**Detroit
Edison**

Reference: Enrico Fermi Atomic Power Plant, Unit 2
NRC Docket No. 50-341

Subject: Fuel Pool Cooling System -
Additional Information

Response to NRC Questions
Enrico Fermi Unit 2 High Density
Spent Fuel Storage System

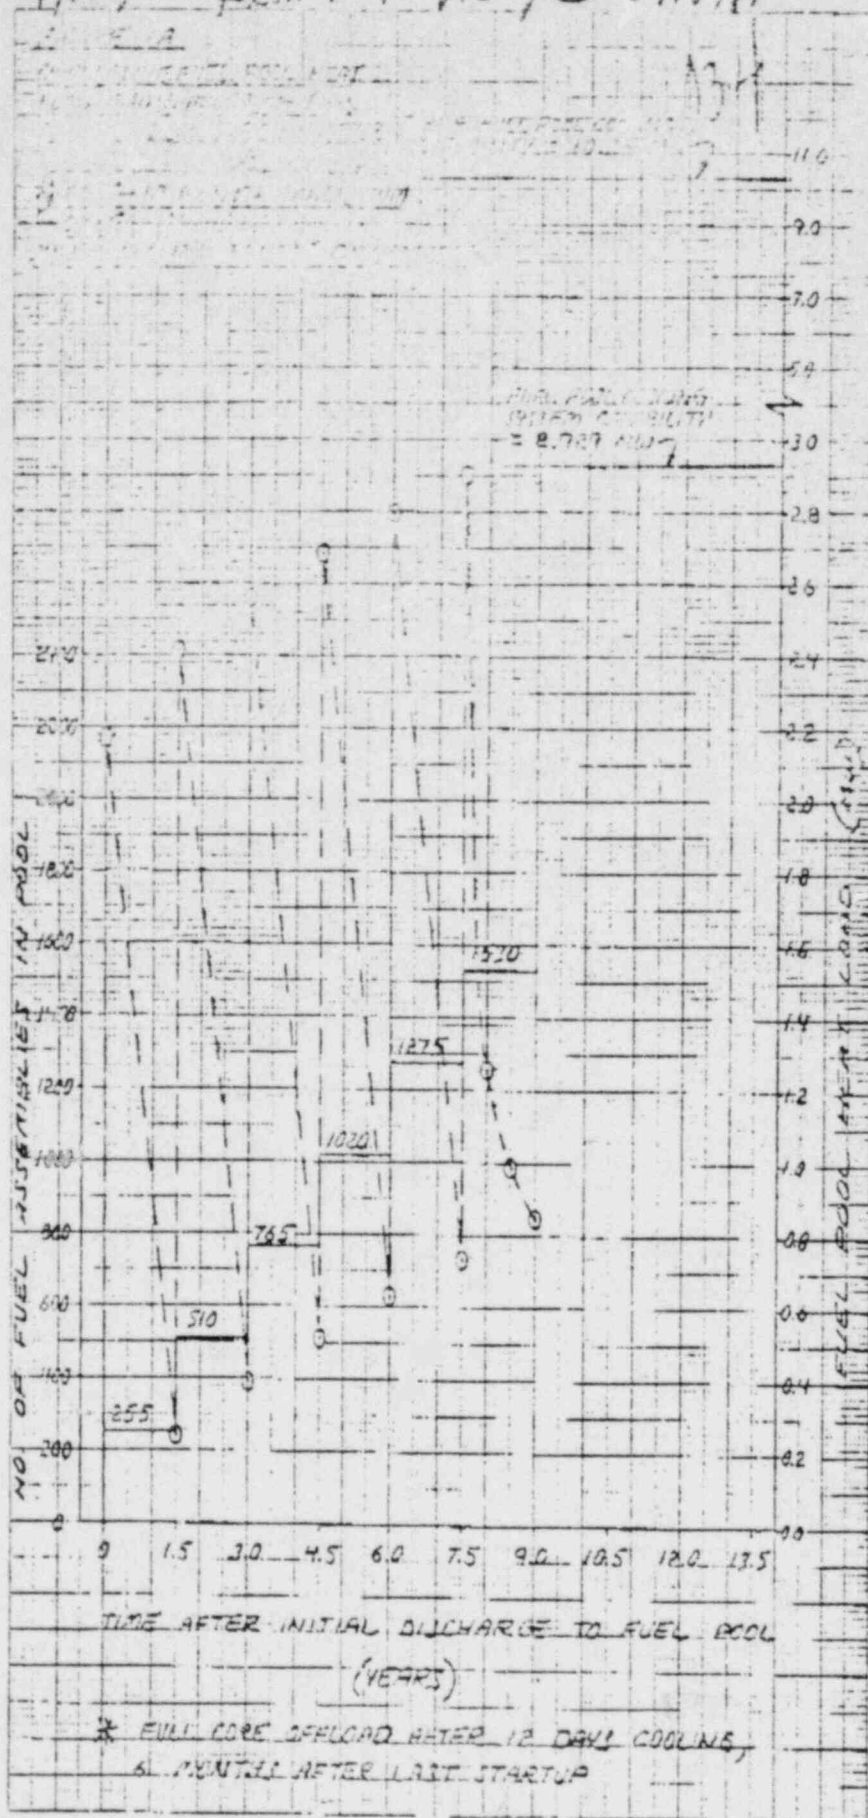
- (f) Using the cumulative decay heat values developed above provide a plot of the total heat load assuming a full core discharge were to occur instead of a normal discharge at each refueling periods. Superimpose on the plot the heat removal capacity of the spent fuel pool cooling system, the RHR system and the combined spent fuel pool cooling system and RHR system

(f) We have determined the worst case maximum cumulative decay heat to occur after 288-hr decay, 180 days after the final normal core discharge (2.0 cores in the pool). The attached figure shows that this heat load is below the heat removal capability of the RHR system when aligned to the ~~fuel pool cooling~~ ^{FPCC} system.

FIGURE 9.1-25

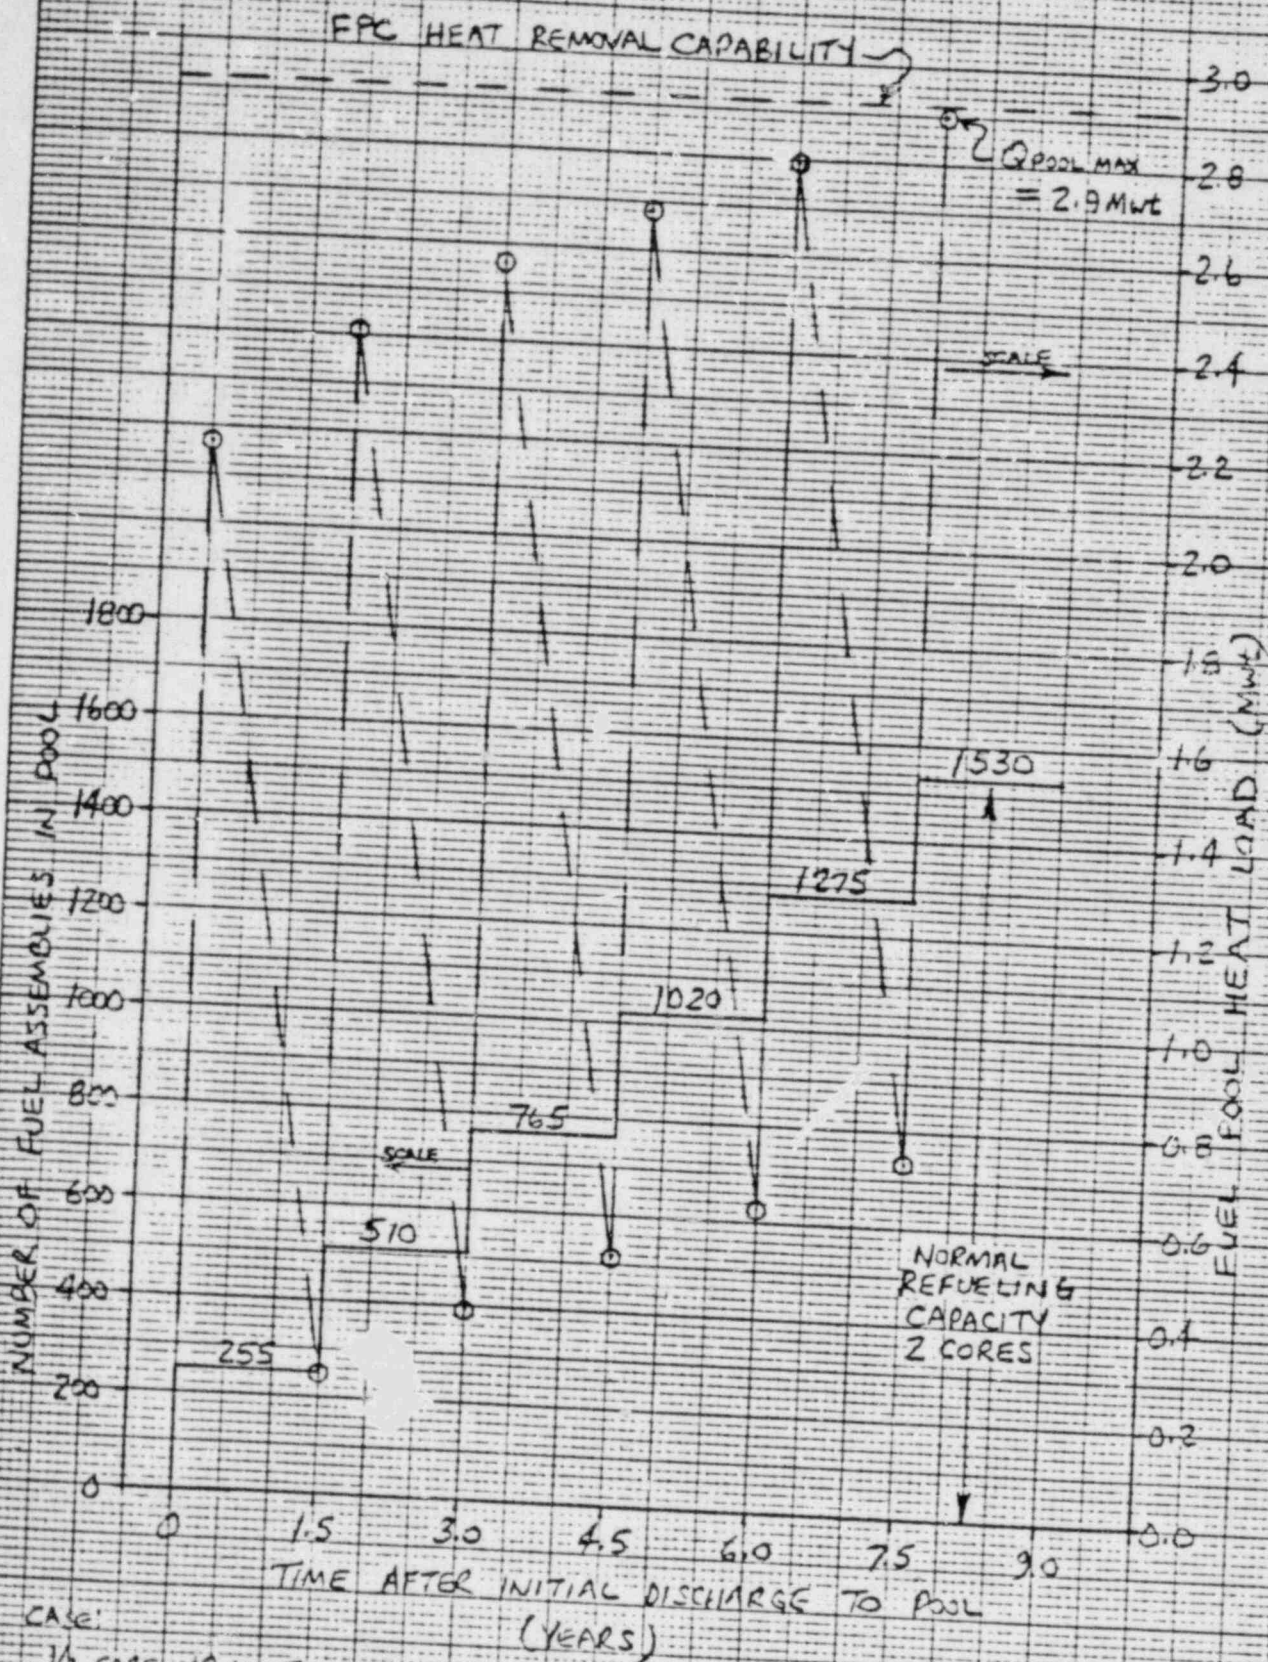
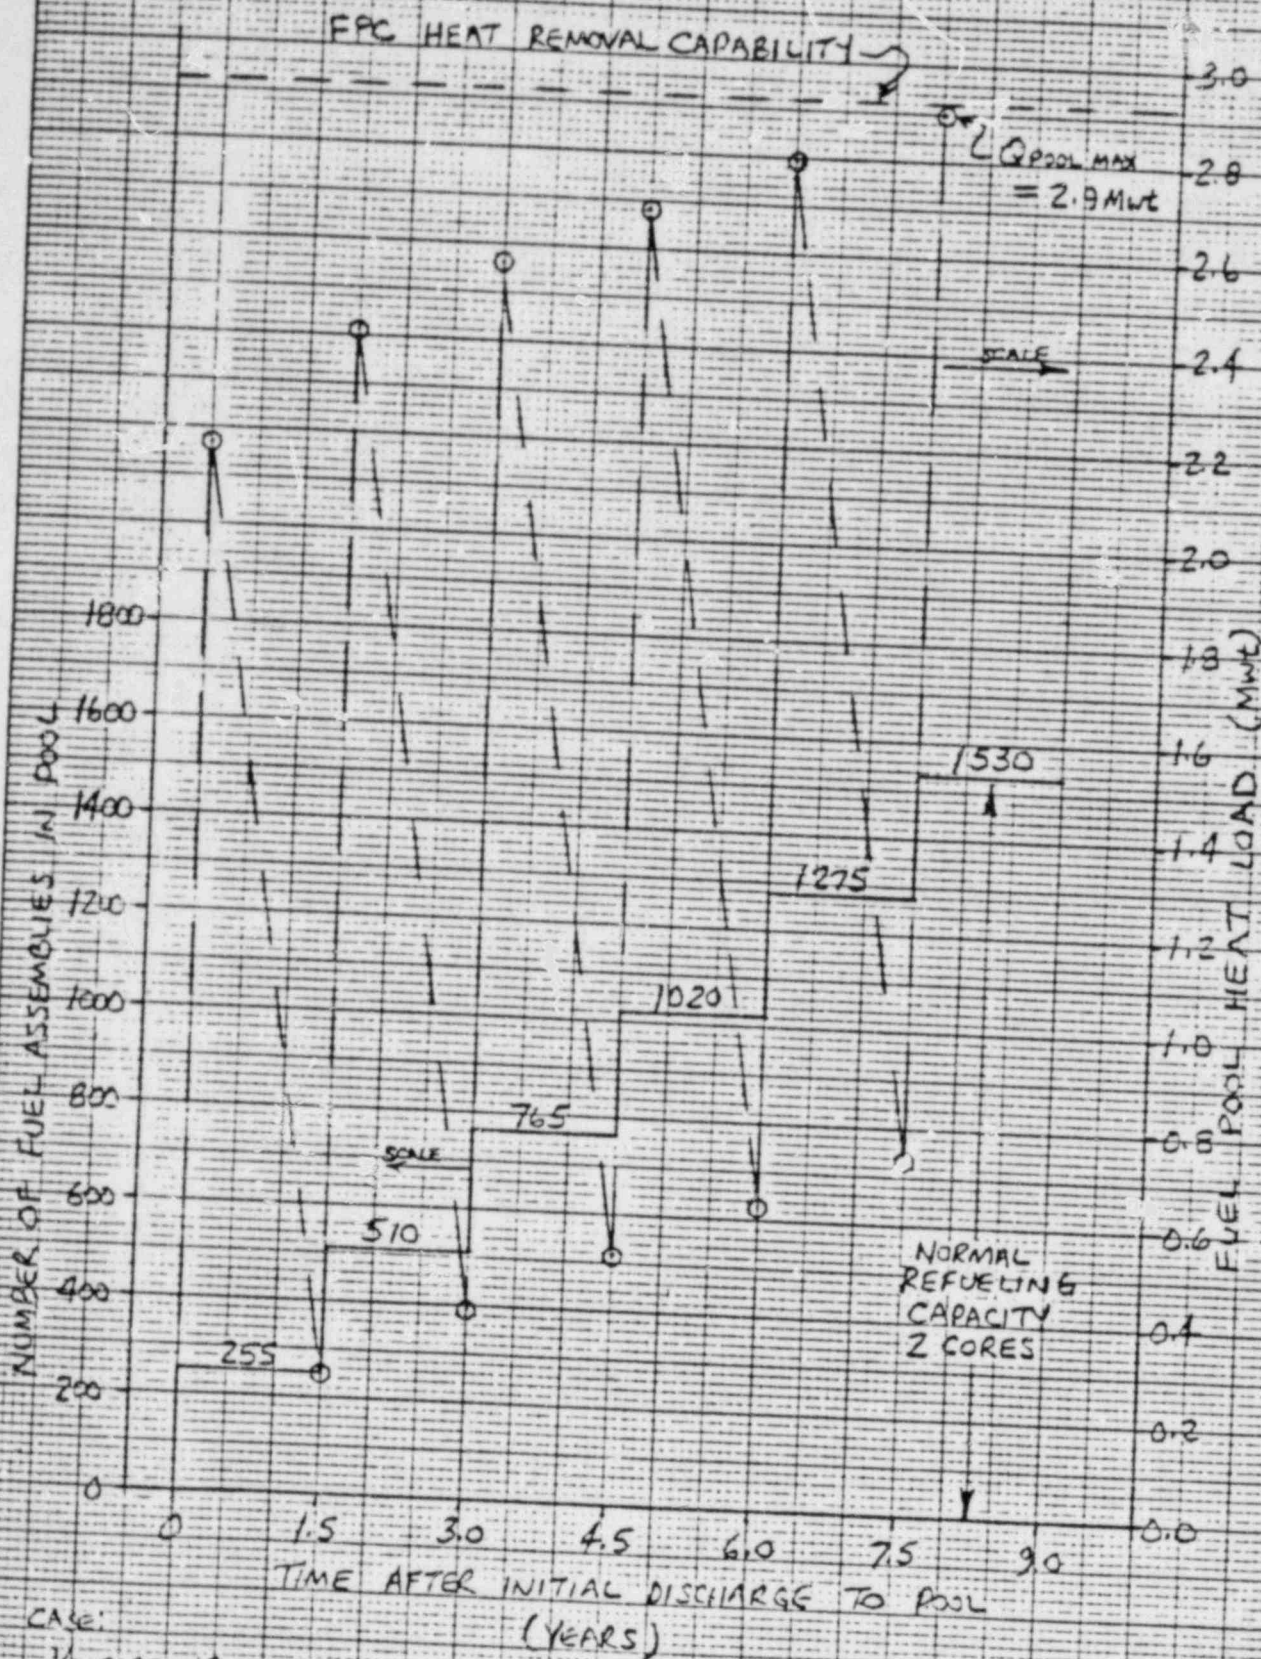
- (d) Using that normal refueling cycle which yields the maximum decay heat load, provide a plot of the cumulative spent fuel pool heat load versus time similar to Figure 9.1-25 in Amendment 32.

Superimpose on the plot the rated heat removal capacity of the spent fuel pool cooling system, the heat removal capacity of the RHR system and the combined heat removal capacity of the spent fuel pool cooling system and the RHR system.

(d) The worst case normal refueling cycle as covered in Item 2a above has been plotted on the attached revision to Figure 9.1-25. The RHR System heat removal capacity is not shown on this figure, but it is well above the heat removal capacity of the FPCCS.
